In re Patent No. 6,032,898

Title: MULTIPLE ROLL TOWEL DISPENSER

PETITION FOR CERTIFICATE OF CORRECTION PURSUANT TO 37 C.F.R. §§ 1.322 and 1.323

Replacement Sheet 1 of 4

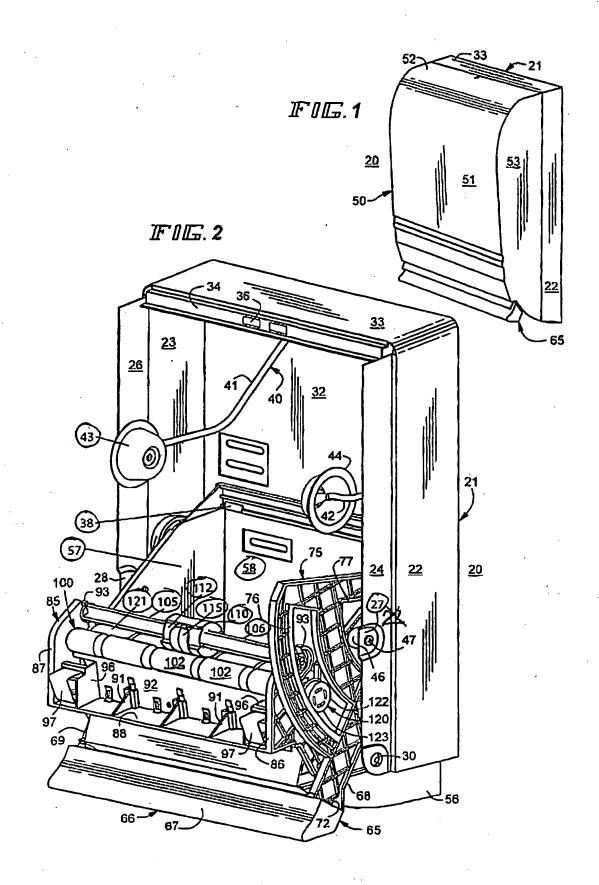
In the drawings, sheet 1, Fig. 2, reference numeral "22" on the sidewall of outwardly extending flange 24 should be deleted and reference numeral --27-- should be applied to the stamped portion;

In the drawings, sheet 1, Fig. 2, reference numeral -43-- should be applied to the lefthand side hub of the paper roll holder assembly 40; reference numeral --58- should be applied to

the rear wall of the chassis 55; reference numeral -57- should be applied to the left-hand side spaced parallel side wall of chassis 55; reference numeral -38-- should be applied to the clip extending from the rear wall 32 of the housing 21.

In the drawings, sheet 1, Fig. 2, reference numeral --121-- should be applied to the drive roller segments of the drive roller 120.

In the drawings, sheet 1, Fig. 2, reference numeral -105-- should be applied to the transfer roller assembly; reference numeral -106-- should be applied to the shaft 106 of the transfer roller assembly 105; reference numeral -110-- should be applied to the transfer mechanism; reference numeral -112-- should be applied to the indented or removed portion of the cylindrical portion 111 of the shaft 106; reference numeral --115-- should be applied to the snap clip which receives the indented or removed portion 112 of the cylindrical portion 111 of the shaft 106.

Multiple Roll Towel Dispenser
Inventor: LaCount et al.
U.S. Patent No. 6,032,898
Atty Docket No. ALW-113REX
Red-Lined Version
Replacement Sheet 2 of 4

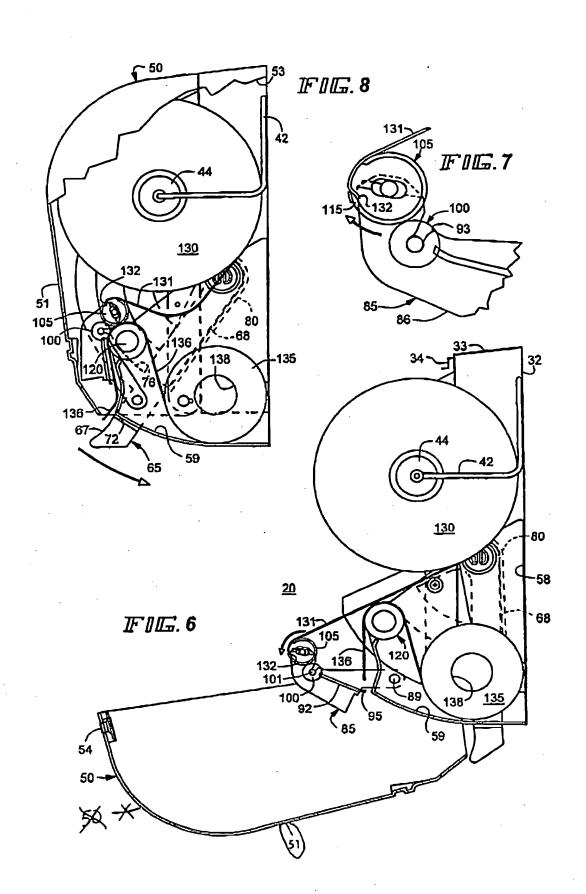
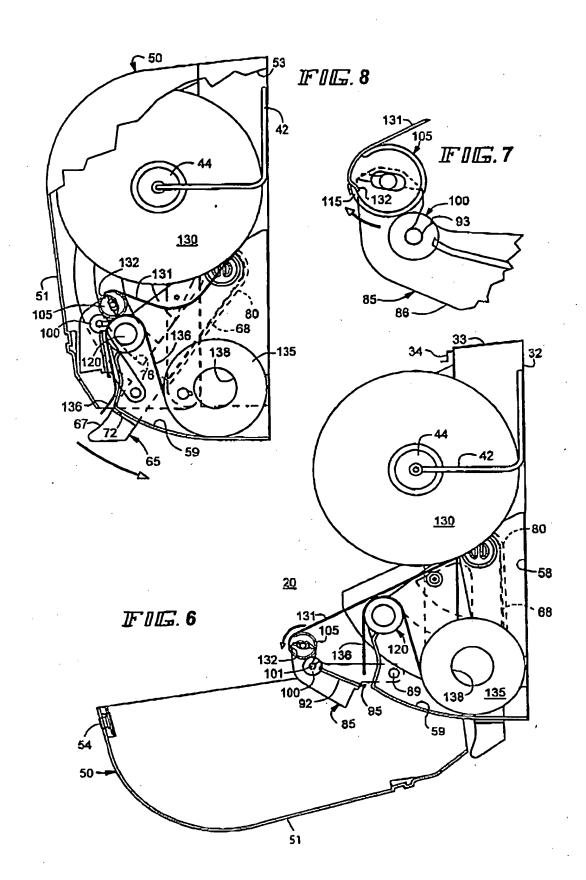
In the drawings, sheet 3, Fig. 6, the reference numeral "50" (not the reference numeral "50" pointing to the cover) should be deleted and reference numeral -51-- should be applied to the front panel of the cover 50.

Multiple Roll Towel Dispenser
Inventor: LaCount et al.
U.S. Patent No. 6,032,898
Atty Docket No. ALW-113REX
Red-Lined Version
Replacement Sheet 3 of 4

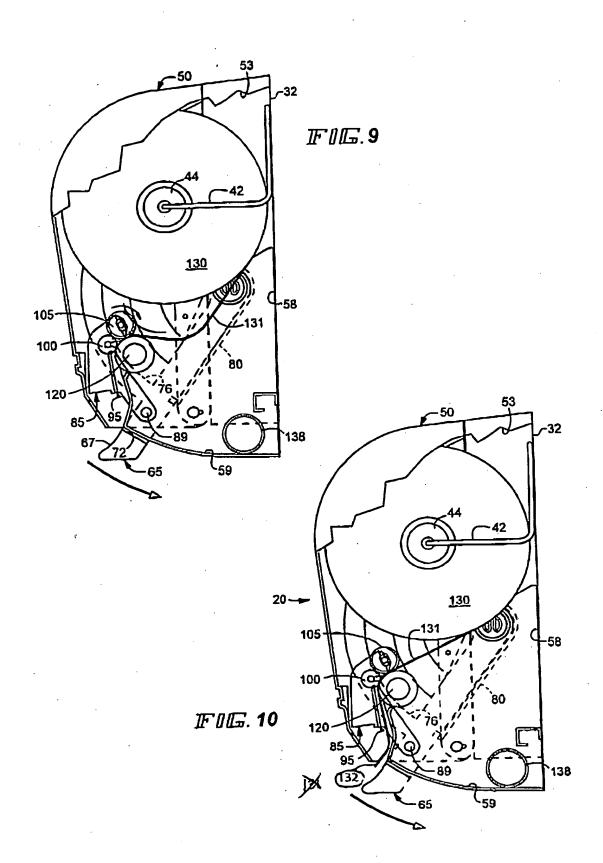
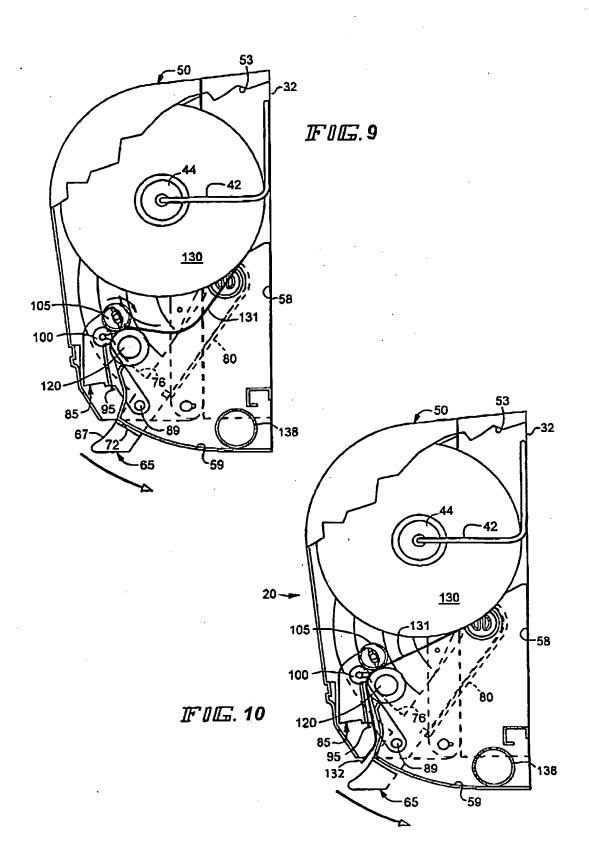
In the drawings, sheet 4, Fig. 10, the reference numeral "131" pointing to the free end of the flight of paper 131 should be deleted and the reference numeral --132-- should be applied to the free end of the flight of paper 131.

Multiple Roll Towel Dispenser
Inventor: LaCount et al.
U.S. Patent No. 6,032,898
Atty Docket No. ALW-113REX
Red-Linco Version
Replacement Sheet 4 of 4

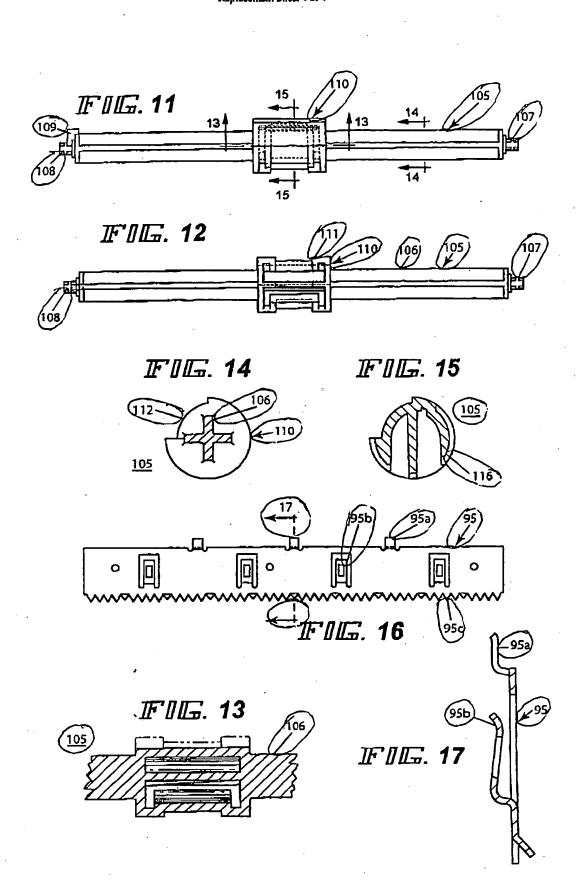
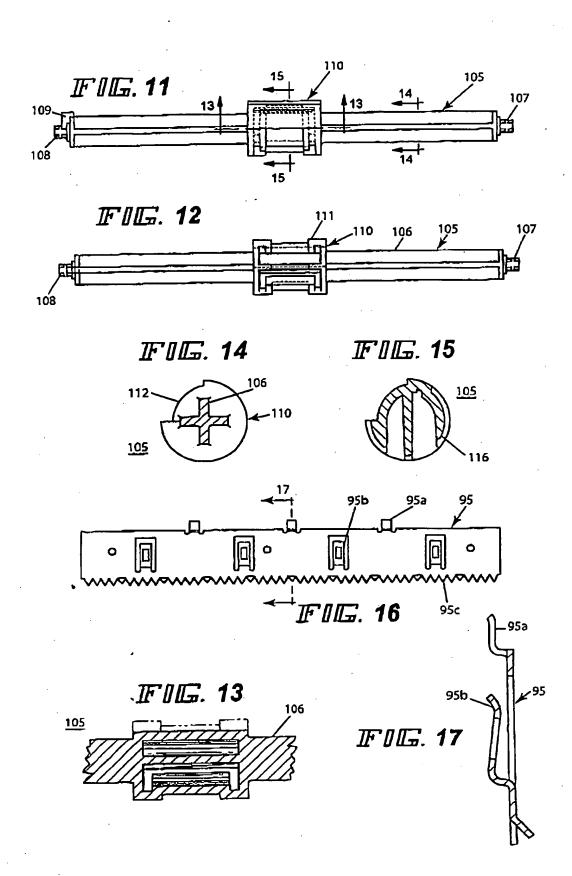
In the drawings, sheet 5, Fig. 11, reference numeral -105- should be applied to the transfer roller assembly; reference numeral -107- should be applied to the journal on the right-hand end of the transfer roller assembly 105; reference numeral --108- should be applied to the

journal on the left-hand end of the transfer roller assembly 105; reference numeral -109- should be applied to the stop plate on journal 108; and reference numeral -110- should be applied to the transfer mechanism positioned generally centrally of the shaft of the transfer roller assembly 105.

In the drawings, sheet 5, Fig. 12, reference numeral --105— should be applied to the transfer roller assembly; reference numeral --106— should be applied to the shaft of the transfer roller assembly 105; reference numeral --107— should be applied to the journal on the right-hand end of the transfer roller assembly 105; reference numeral --108--- should be applied to the journal on the left-hand end of the transfer roller assembly 105; reference numeral --110--- should be applied to the transfer mechanism positioned generally centrally of the shaft 106; and reference numeral --111--- should be applied to cylindrical portion of the shaft 106.

In the drawings, sheet 5, Fig. 13, reference numeral --105-- should be applied to the transfer roller assembly; and reference numeral --106-- should be applied to the shaft of the transfer roller assembly.

In the drawings, sheet 5, Fig. 14, reference numeral -105-- should be applied to the transfer roller assembly; reference numeral --106-- should be applied to the shaft of the transfer roller assembly 105; reference numeral --110-- should be applied to the transfer mechanism positioned generally centrally of the shaft 106; and reference numeral --112-- should be applied to the indented or removed portion of the cylindrical portion 111 of the shaft 106.

In the drawings, sheet 5, Fig. 15, reference numeral --105-- should be applied to the transfer roller assembly; and reference numeral --116-- should be applied to the groove or

receptacle of the cylindrical portion 111 of the shaft 106.

In the drawings, sheet 5, Fig. 16, reference numeral -95- should be applied to the tear bar, reference numeral -95a- should be applied to the tabs of the tear bar 95; reference numeral -95b- should be applied to the clips of the tear bar 95; reference numeral -95c- should be applied to the serrated edge of the tear bar 95; and section line 17-17 should be added at the middle portion of the drawing at the top and bottom thereof.
